SUBJECT: NuScale Power, LLC Supplemental Response to NRC Request for Additional Information No. 196 (eRAI No. 9050) on the NuScale Design Certification Application

Enclosure 1: NuScale Supplemental Response to NRC Request for Additional Information eRAI No. 9050

NRC Question No.: 16-18

Figure 7.1-1k: ESFAS - Containment System Isolation, Chemical and Volume Control System Interlocks

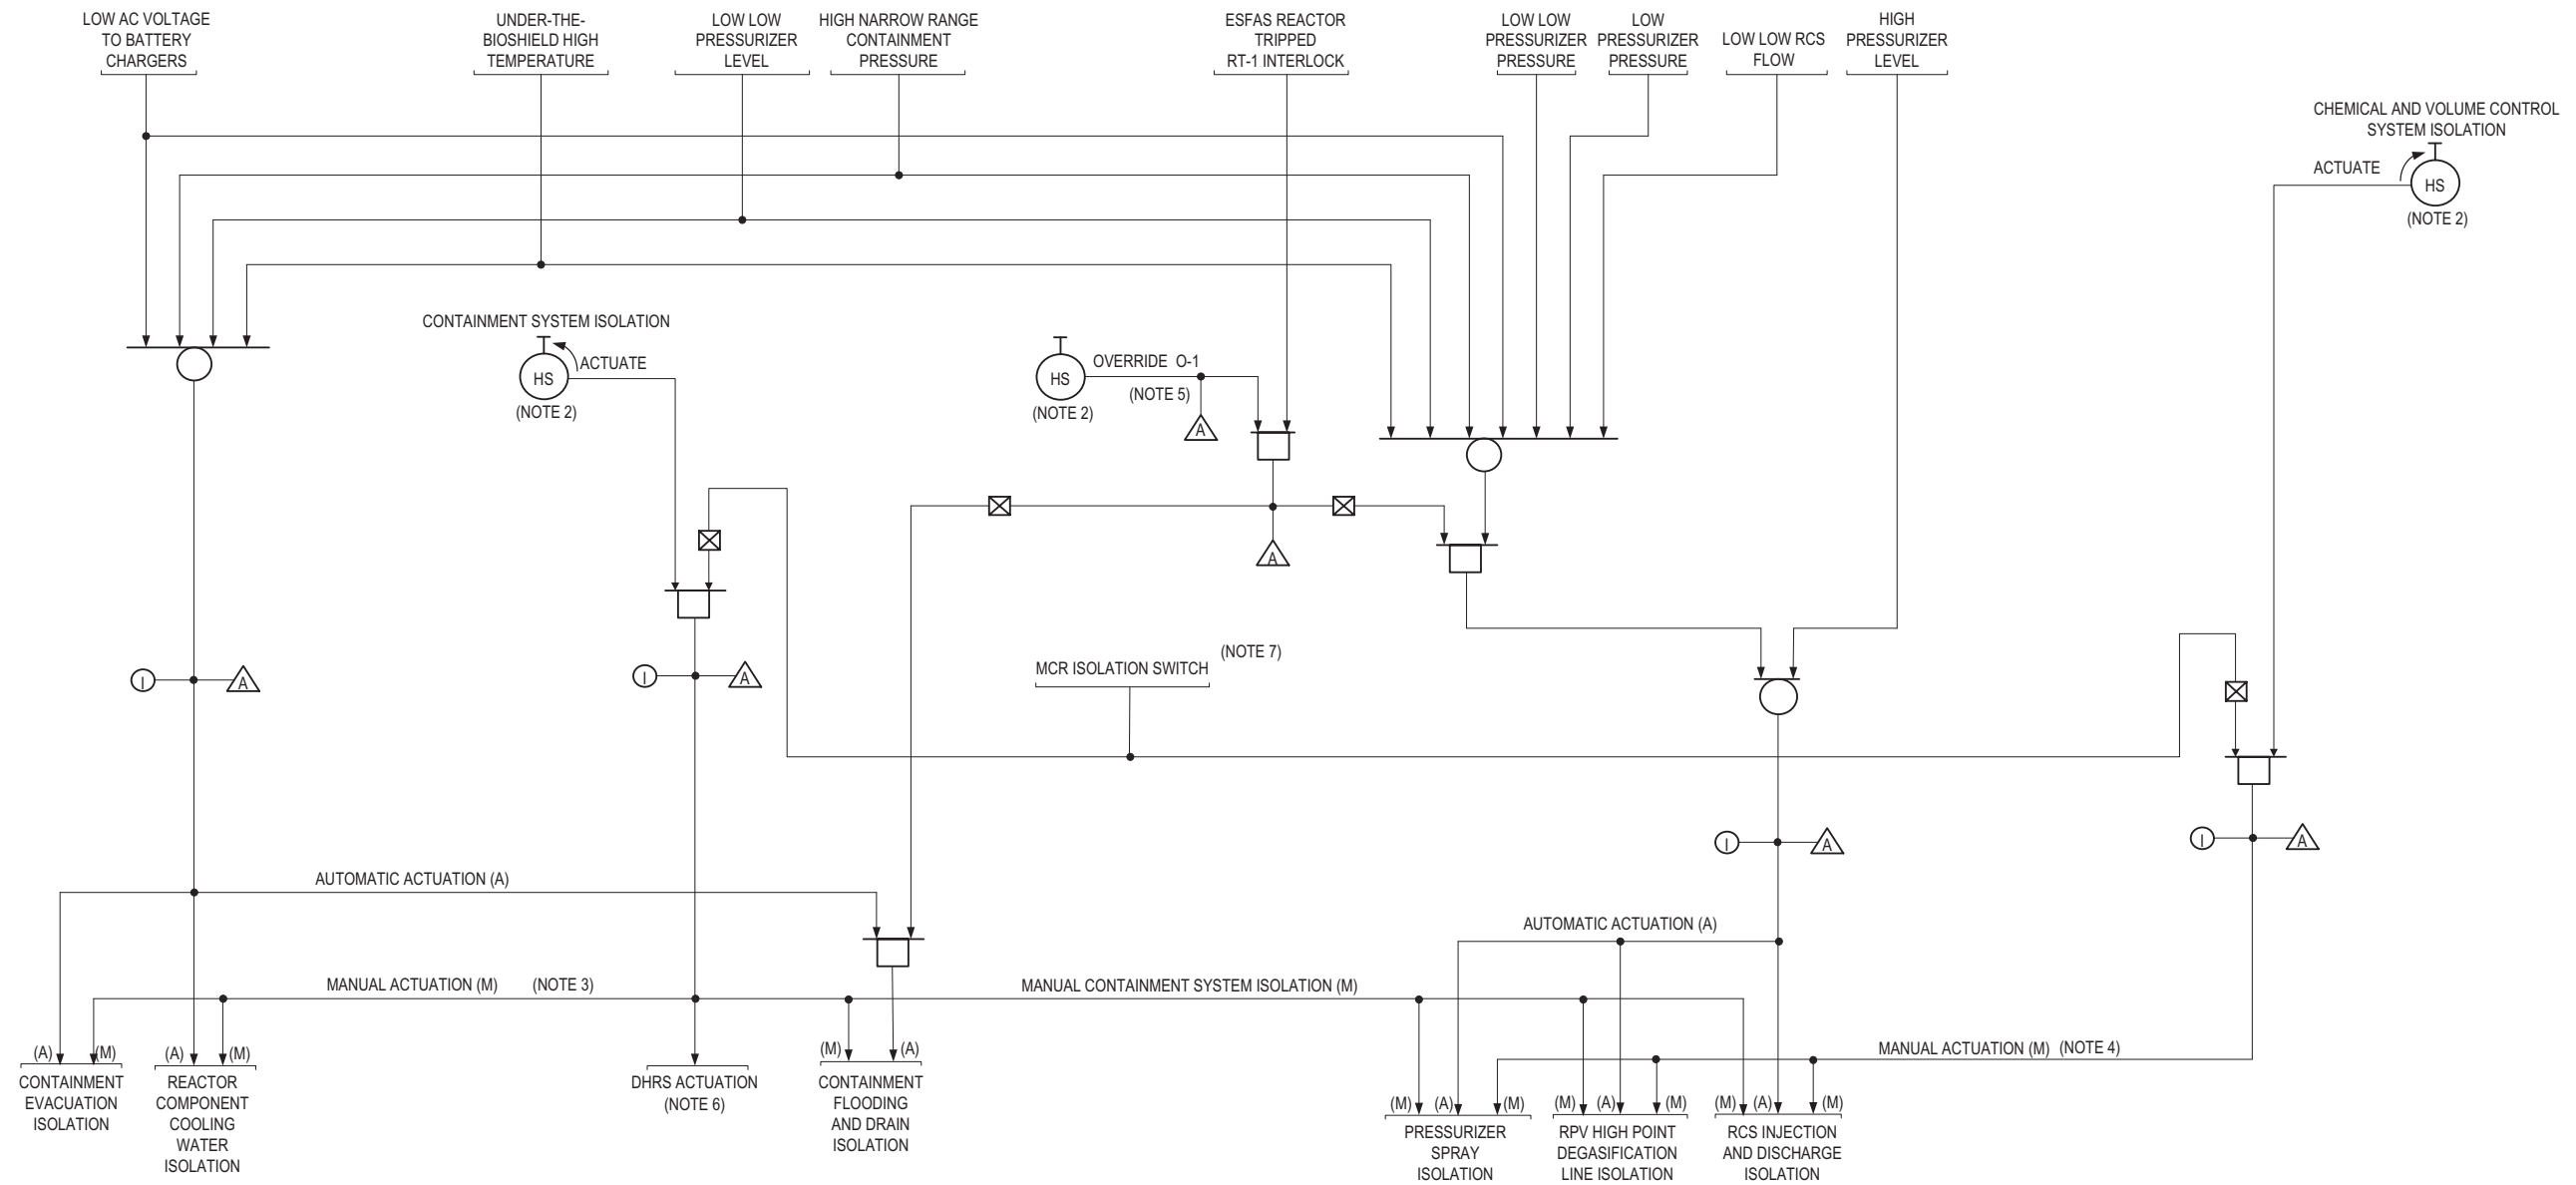
portions of the MPS and actuations described in LCO 3.3.3, however no additional changes are proposed because those Bases refer to the description provided in the Bases for LCO 3.3.1. Additionally, some changes were made to Chapter 7, "Instrumentation and Controls," Table 7.1-5, "Module Protection System Interlocks / Permissives / Overrides," and Figure 7.1-1k, "ESFAS - Containment System Isolation, Chemical and Volume Control System Interlocks," of the FSAR to describe the design and function of the O-1 override.
